## ORIGINATION FORM

Proposed Revisions to a Standard Plans Index  
(Please provide all information — Incomplete forms will be returned)

Index Number: 700-120

Index Title: Enhanced Highway Signing Assemblies

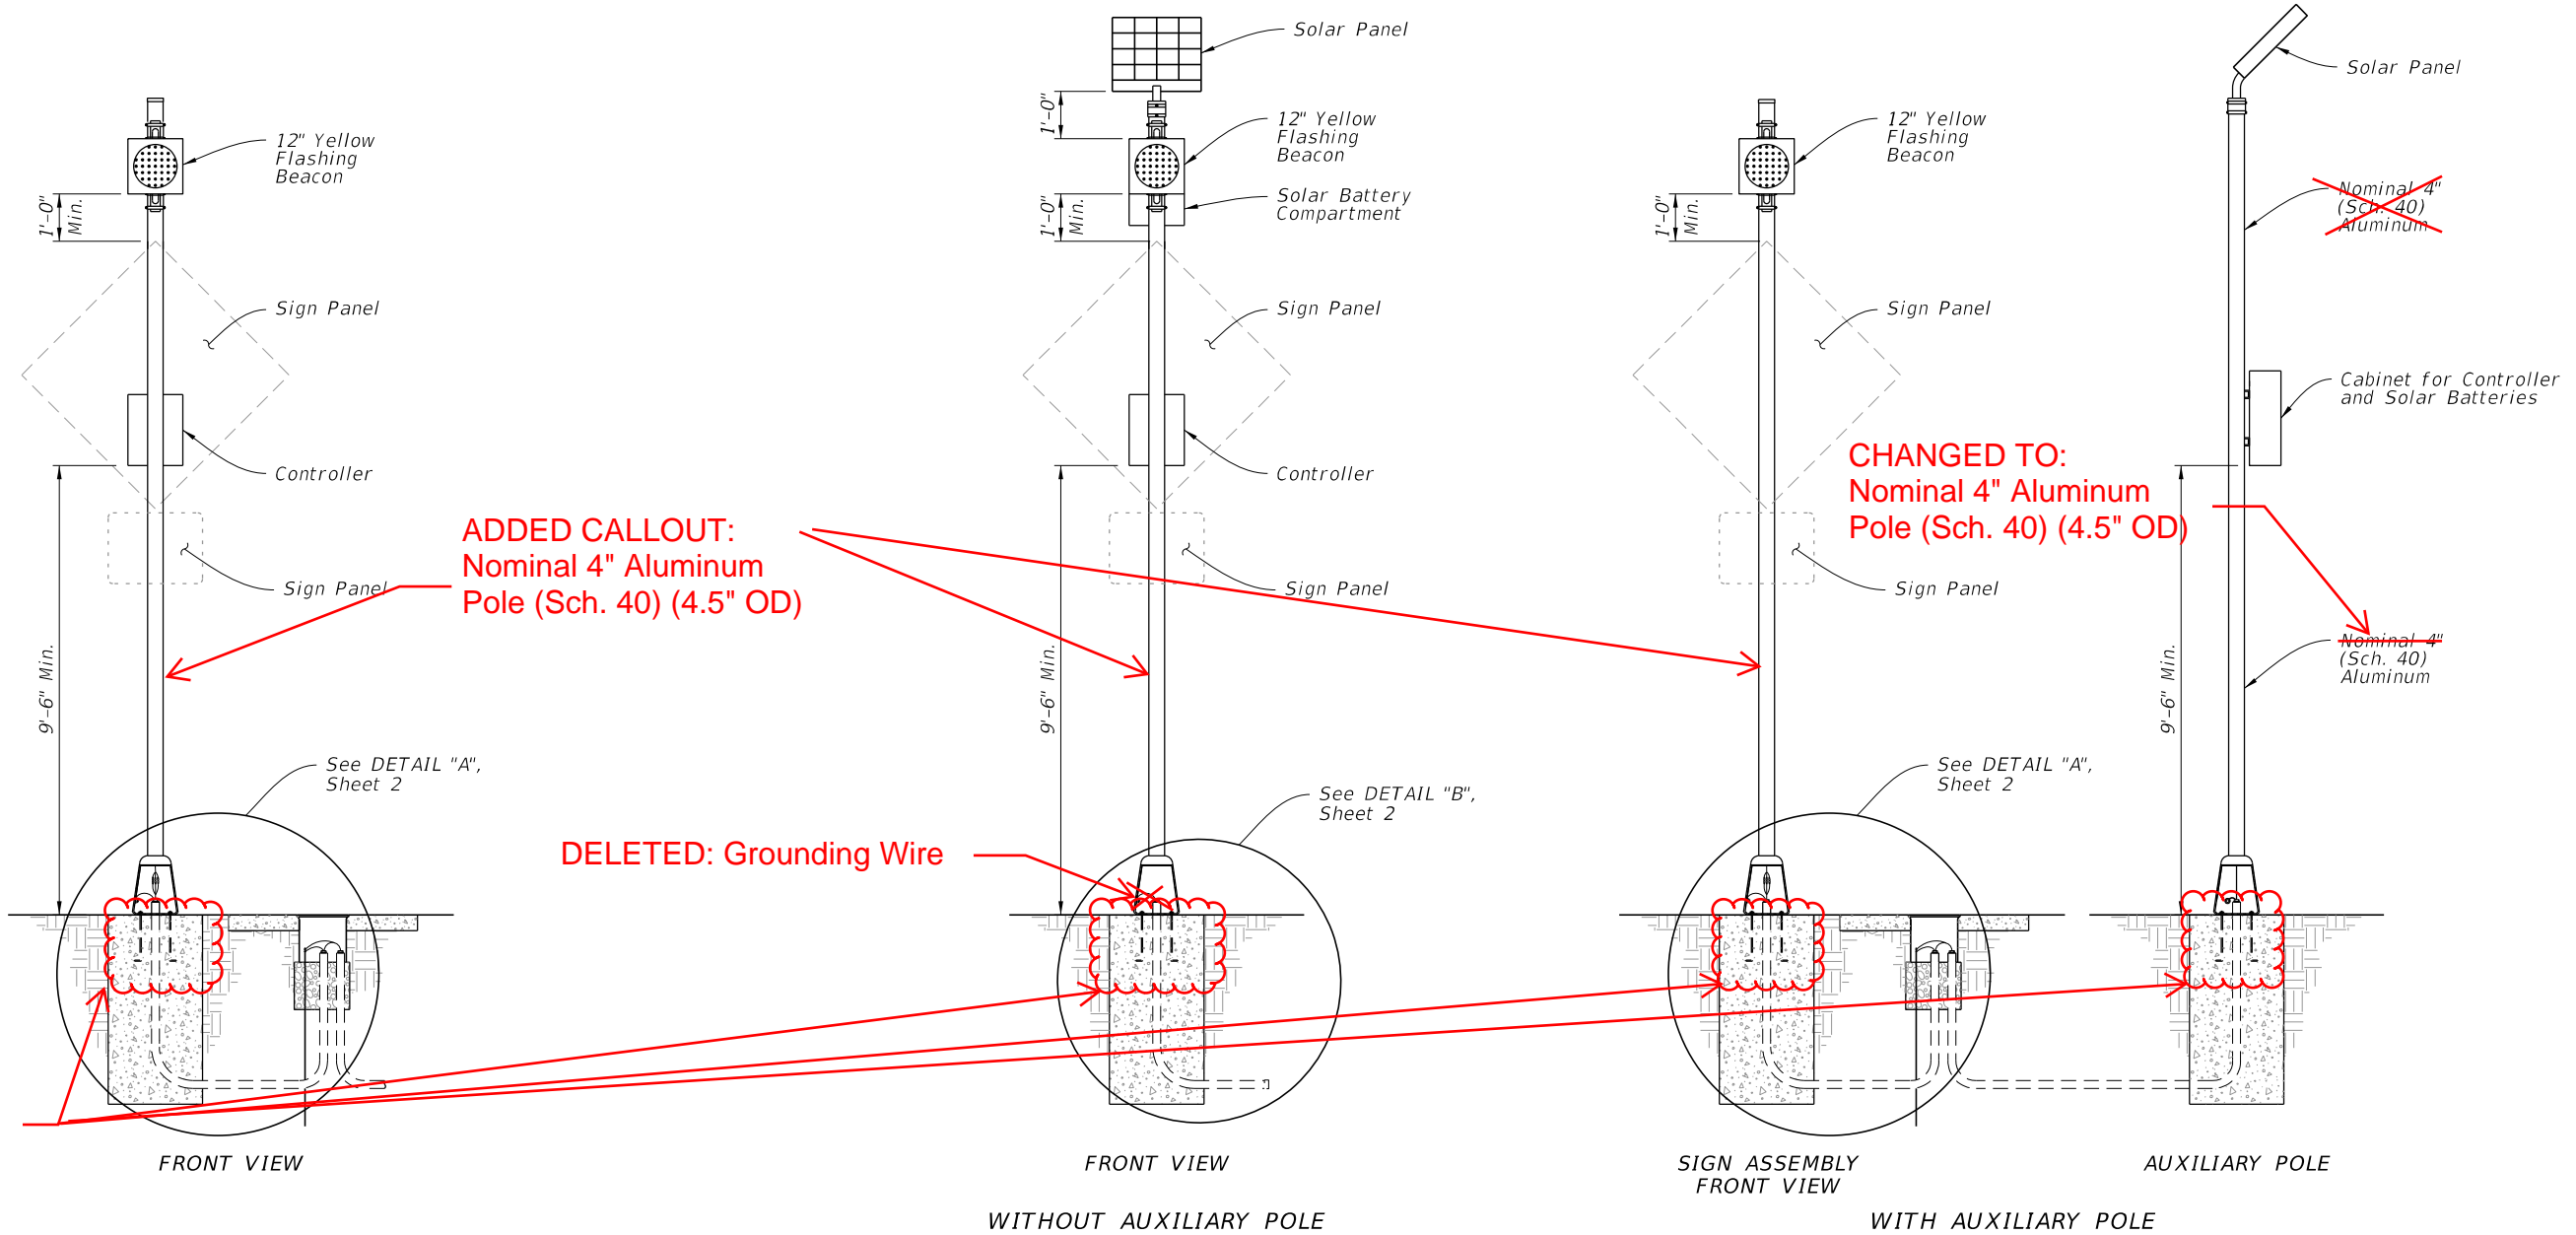
UPDATED: Anchor Bolts

**POWER CONFIGURATION 'A'**  
**CONVENTIONALLY-POWERED**  
 (Type A1 Shown)

CHANGE TO:  
Nominal 4" Aluminum  
Pole (Sch. 40) (4.5" OD)

- Sheet 1: Updated General Note 4; Change all references "4" Nominal Aluminum Pole" to "Nominal 4" Aluminum Pole (Sch. 40) (4.5" OD)"; Updated anchor bolts.
- Sheet 2: Add new detail to show foundation reinforcement; Change all references "4" Nominal Aluminum Pole" to "Nominal 4" Aluminum Pole (Sch. 40) (4.5" OD)"; Updated anchor bolts.
- Sheets 3 through 11: Updated callouts to point to both details; Change all references "4" Nominal Aluminum Pole" to "Nominal 4" Aluminum Pole (Sch. 40) (4.5" OD)"; Updated anchor bolts; Added Note "Foundation reinforcement not shown".

CONDUIT, WIRING, AND FOUNDATION DETAILS

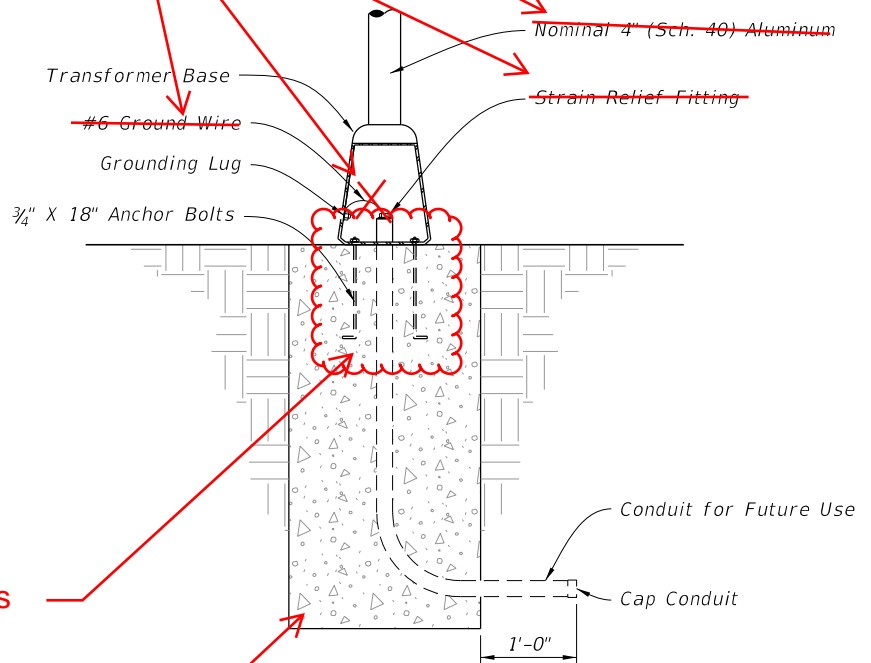
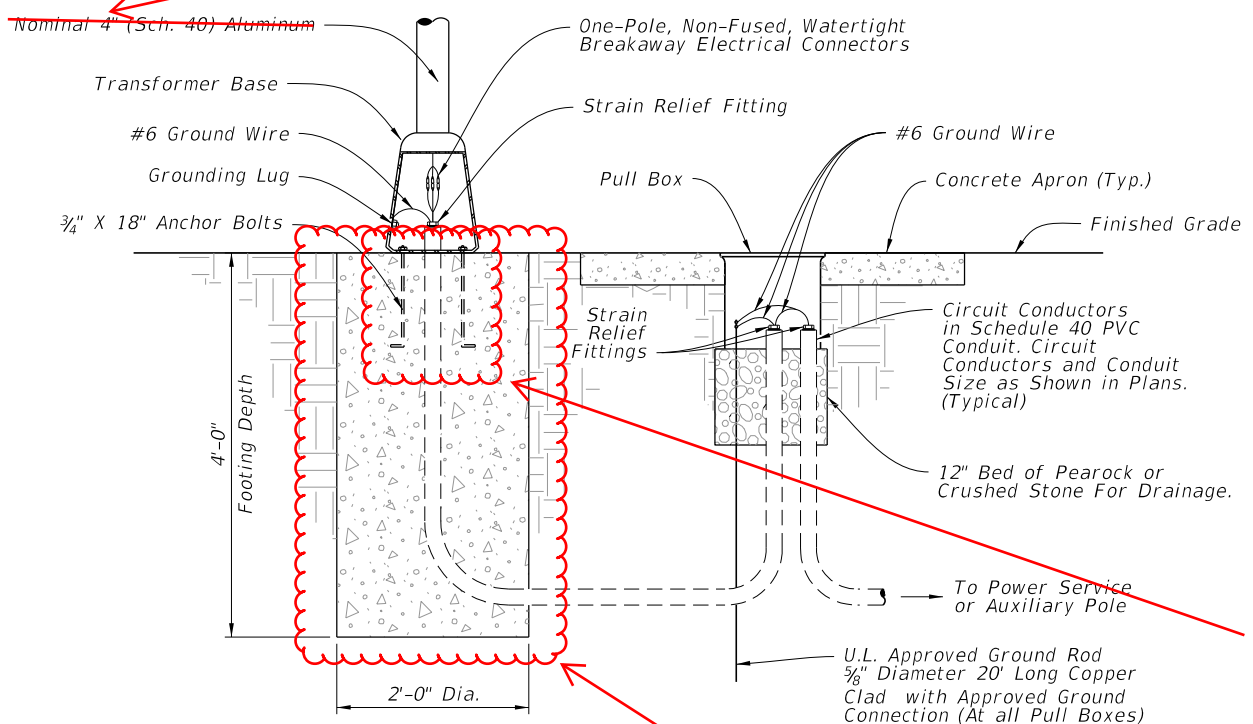
DELETED:

DETAIL "B"

UPDATED: Anchor Bolts

UPDATED TO SHOW REINFORCEMENT

CHANGE TO:  
Nominal 4" Aluminum  
Pole (Sch. 40) (4.5" OD)

UPDATED: Anchor Bolts

Sheet 2: Deleted the ground wire and strain relief fitting from DETAIL "B".

Sheet 2 - A ground wire is not required for a sign assembly without an auxiliary pole. The ground wire will be removed from Detail B on Sheet 2.

**ROADSIDE SIGN ASSEMBLY-1**

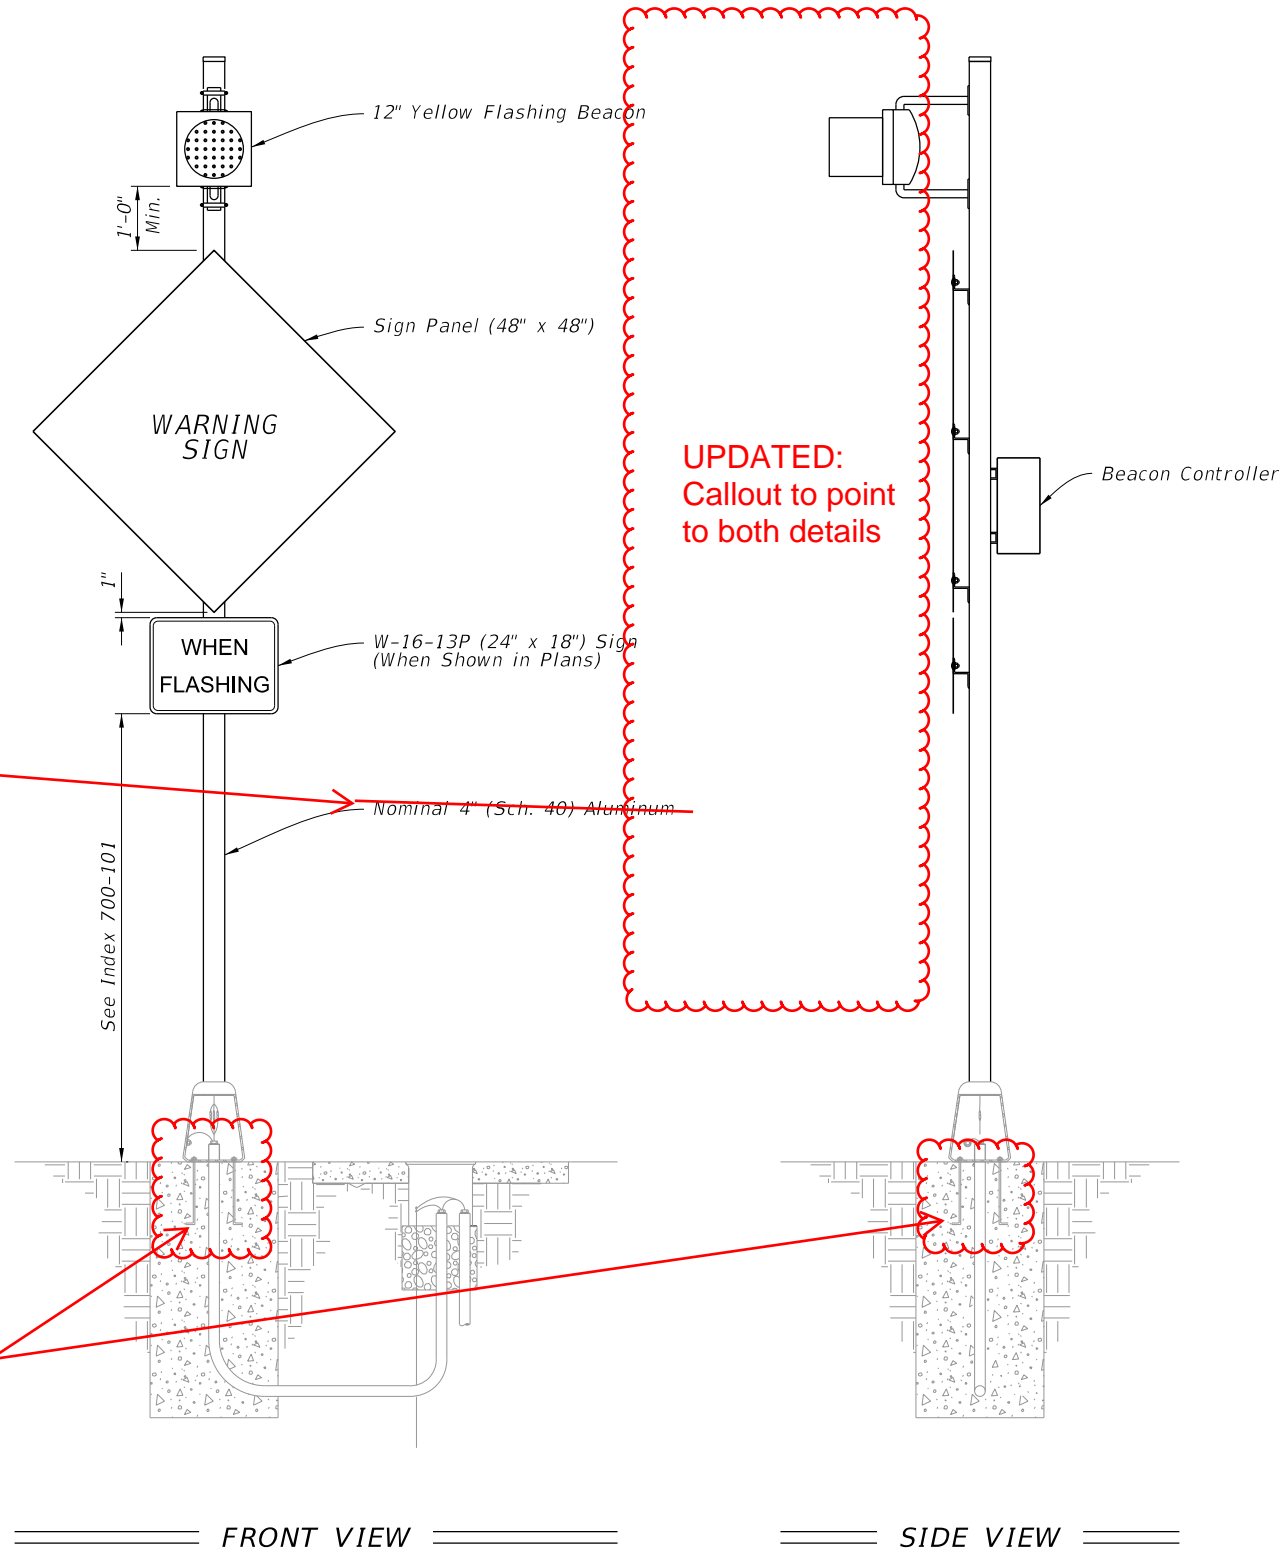
UPDATED:  
Callout to point  
to both details

**ADDED NOTE:**

Foundation reinforcement not shown.

ROADSIDE SIGN ASSEMBLY-2

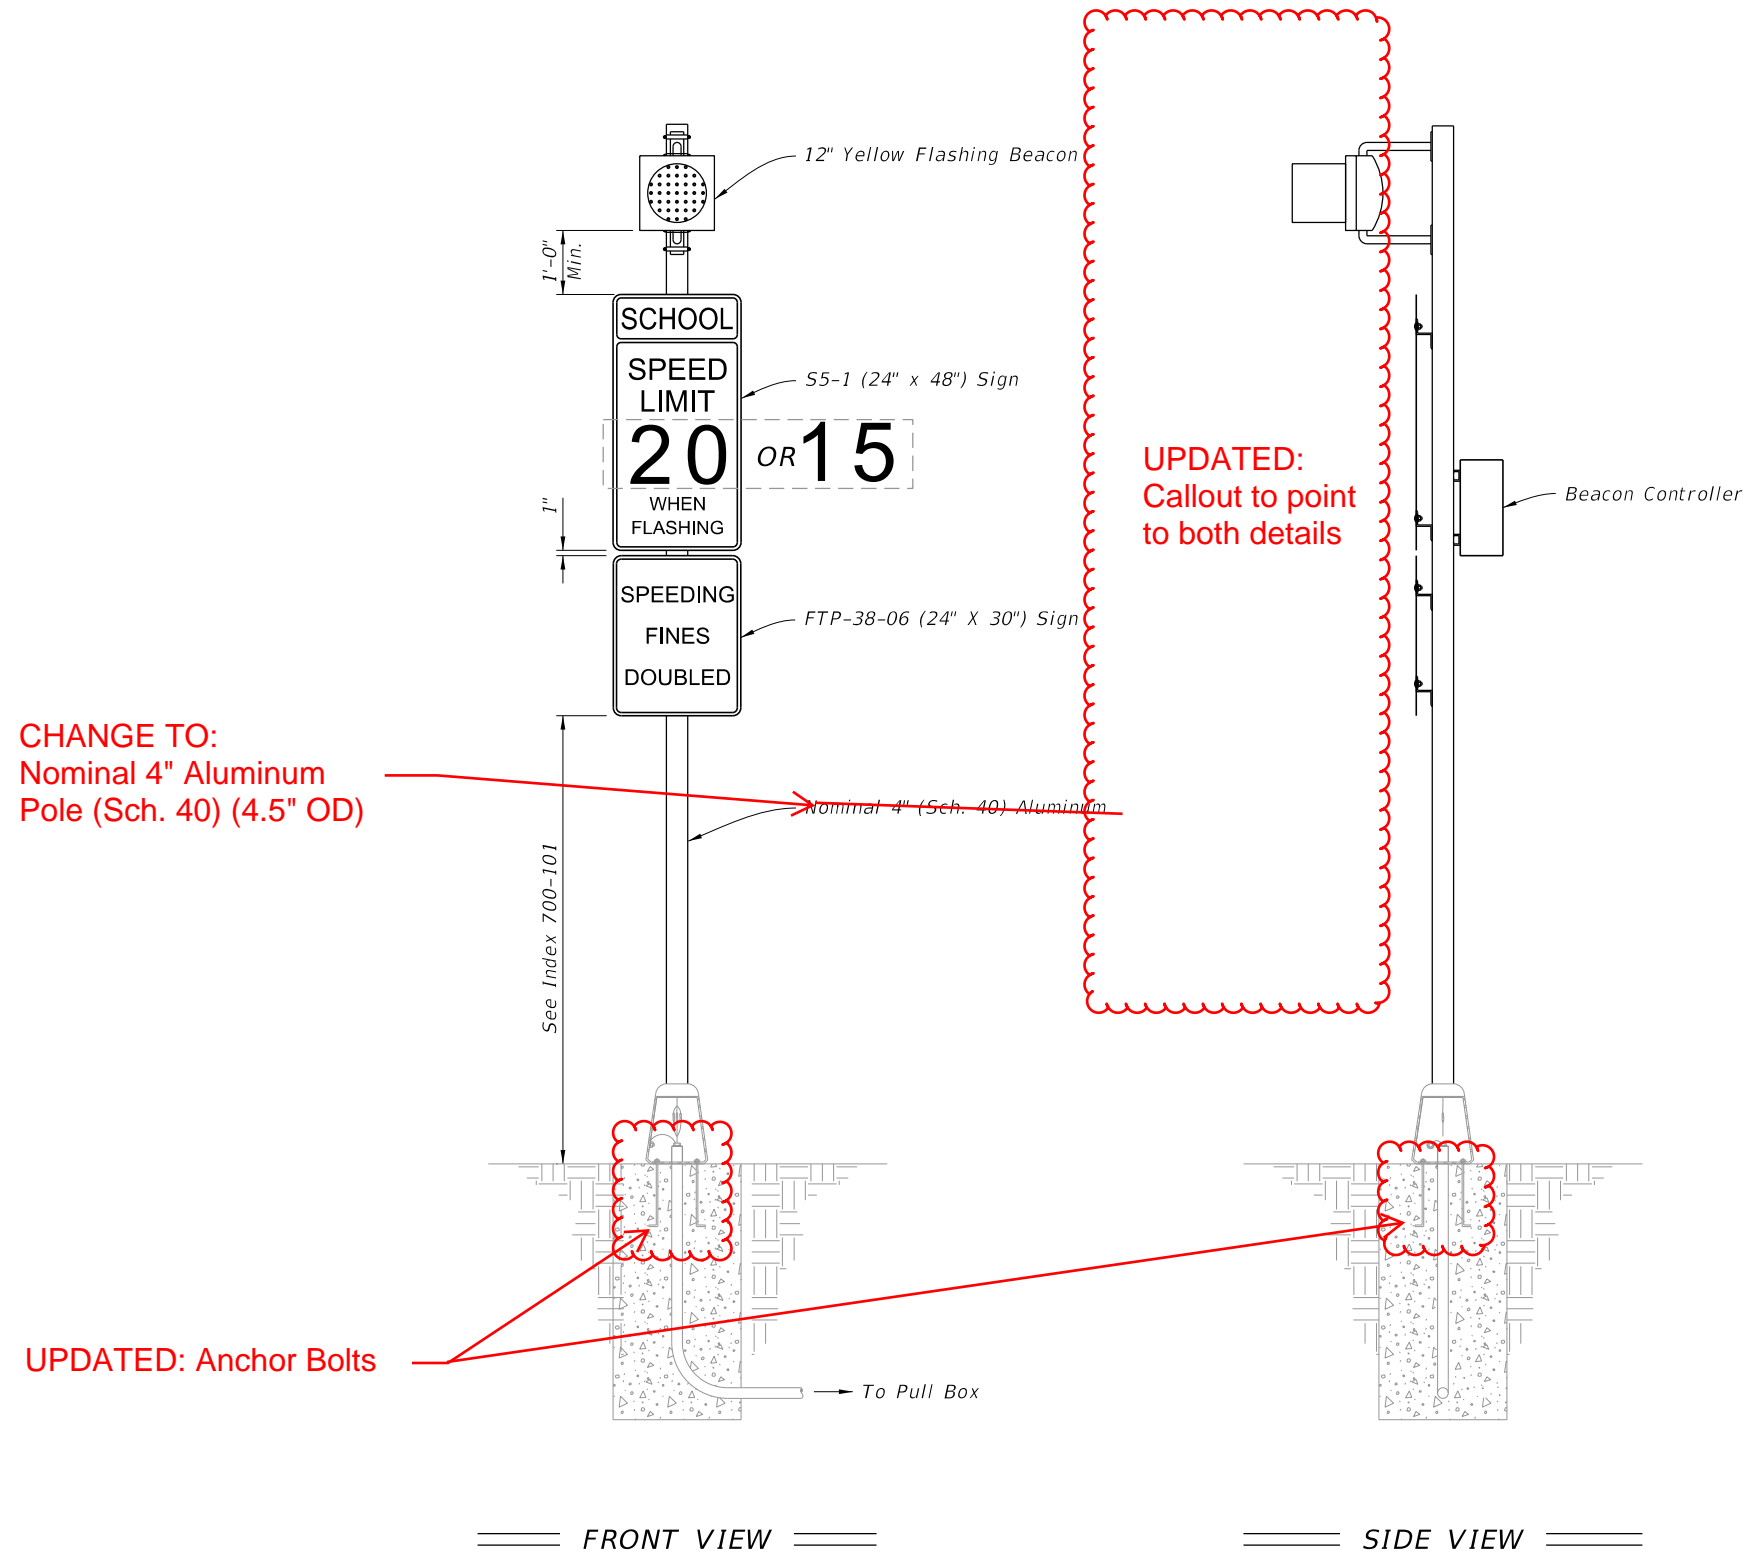
**ADDED NOTE:**  
 Foundation reinforcement not shown.
